DRAFT MERTON CHARACTER STUDY Response from Mitcham Cricket Green Community & Heritage March 2021

Cricket Green

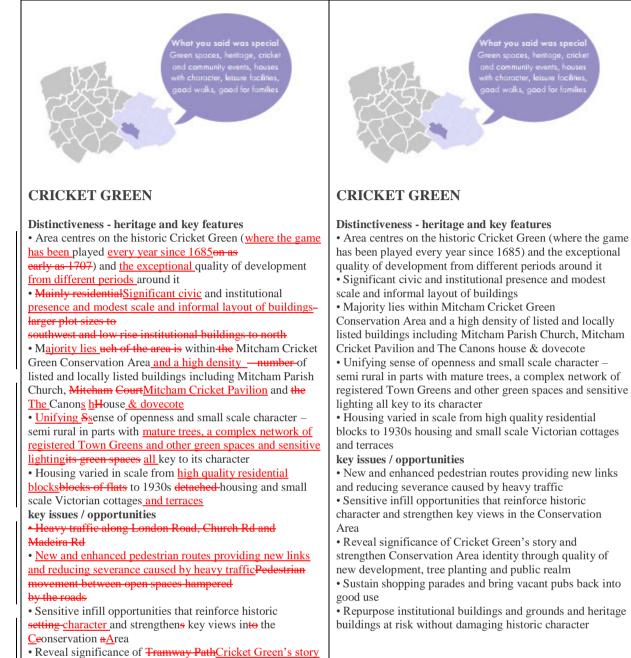
18. Notwithstanding this fundamental shortcoming we have tracked our proposed changes to the text for Cricket Green below. The amended text is just 50 words longer than the original and we commend its use. The amendments also address a critical error in the original text by recording that cricket has been played on the historic ground every year since 1685 and not 1707 as provided in the draft. This is a key consideration given the character of this neighbourhood is so enriched by it being the location of the oldest cricket ground in the world. The ideas/opportunities are informed by the Cricket Green Charter. This presents the conclusions of dialogue with local people, including a community workshop organised by Mitcham Cricket Green Community & Heritage working with the Future Merton team at Merton Council and local ward councillors. More than 5,000 households were contacted during its preparation and we believe it provides a more robust basis for the following proposals.

TRACKED CHANGES

AMENDED TEXT

and strengthen Conservation Area identity through quality of

new development, tree planting and public realm • Explore opportunities to Sustain shopping parades and bring vacant pubs on Cricket Green back into good use • Repurpose institutional buildings and grounds and heritage buildings at risk without damaging historic character
